UNITED STATES PATENT AND TRADEMARK OFFICE

APPLICATION NO.	FILING DATE	FIRST NAMED INVENTOR	ATTORNEY DOCKET NO.	CONFIRMATION NO.
10/750,312	12/30/2003	Jessica R. DesNoyer	50623.313	1694

Office Action Summary

- 1) ☒ Responsive to communication(s) filed on 01 February 2006.
- 2a) ☒ This action is **FINAL**. 2b) ☐ This action is non-final.
- 3) ☐ Since this application is in condition for allowance except for formal matters, prosecution as to the merits is closed in accordance with the practice under *Ex parte Quayle*, 1935 C.D. 11, 453 O.G. 213.

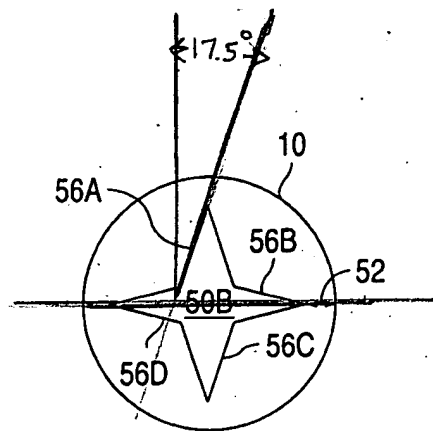
Applicant's arguments filed 2/1/2006 have been fully considered but they are not persuasive. Applicant's argument that Hattler et al fails to teach a stent mandrel support

supporting a stent is found to be non-persuasive. Hattler et al mandrel is capable of supporting a stent since it teaches all the claimed structural elements of the mandrel set forth in the body of the claim, that is, a first member to contact a first end of the substrate, a second member to contact a second end of the substrate, and a third member connecting the first member to the second member and extending through a longitudinal bore of the substrate, the third member shaped and/or sized to eliminate or substantially prevent a coating from being formed on a luminal surface of the substrate during application of a coating substance to the substrate. Note it has been held that a recitation with respect to the manner in which a claimed apparatus is intended to be employed does not differentiate the claimed apparatus from a prior art apparatus satisfying the claimed structural limitations. Ex parte Masham, 2 USPQ 2d 1647 (1987). "[A]pparatus claims cover what a device is, not what a device does." Hewlett-Packard Co. v. Bausch & Lomb Inc., 909 F.2d 1464, 1469, 15 USPQ2d 1525, 1528 (Fed. Cir. 1990). Further, it is noted that the American Heritage Dictionary of the English Language, Fourth Ed. (2000) defines a **stent** as "a slender thread, rod, or **catheter** inserted into a tubular structure, such as a blood vessel, to provide support during or after anastomosis." Applicant's argument that Hattler et al is non-analogous art in that it is not directed to a stent mandrel support supporting a stent for use during coating is found to be non-persuasive. Hattler et al shows a divider supporting a hollow tube to be inserted in a vessel within the body (catheter) as shown in Figure 1 thereby reading on the applicant's claimed mandrel. Further, it is noted that the American Heritage Dictionary of the English Language, Fourth Ed. (2000) defines a **stent** as "a slender

**FIG. 5A**

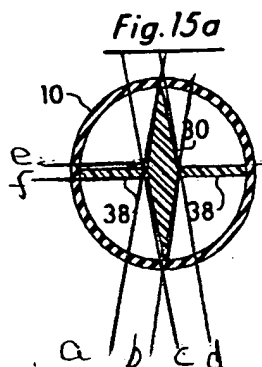
arguments, there is a practical way to describe the invention, different configurations of the mandrel body, in words and therefore, the examiner maintains that the inclusion of the drawings in claim 17 to depict the shape of the mandrel body is improper (see 37 CFR 1.58). Further, although the examiner agrees that applicant can be his or her own lexicographer, the examiner maintains that claim 16 is indefinite since it unclear what the claim encompasses, that is, it fails to clarify the metes and bounds of the claim. For example, applicant refers to configuration 2 as depicted in figures which include Figure 5A and it is unclear when applicant claims the mandrel body has the shape of configuration 2 whether applicant intends to claim that the angle of the inclined side of the vertically oriented upper spike with respect to a normal to the horizontal axis which passes through the center of the star and the peaks of the horizontal spikes is about 17.5 degrees or not. See the drawing below:

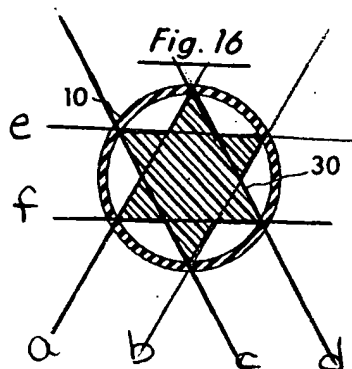
Applicant's argument that Figures 15a and Figure 16 fails to include 3 pairs of opposing parallel sides is found to be non-persuasive. The examiner maintains that

drawings 15a and 16 include at least 3 pairs of opposing parallel sides as depicted

The at least 3 pairs of
opposing parallel
Sides:
1st pair - a, b
2nd pair - c, d
3rd pair - e, f
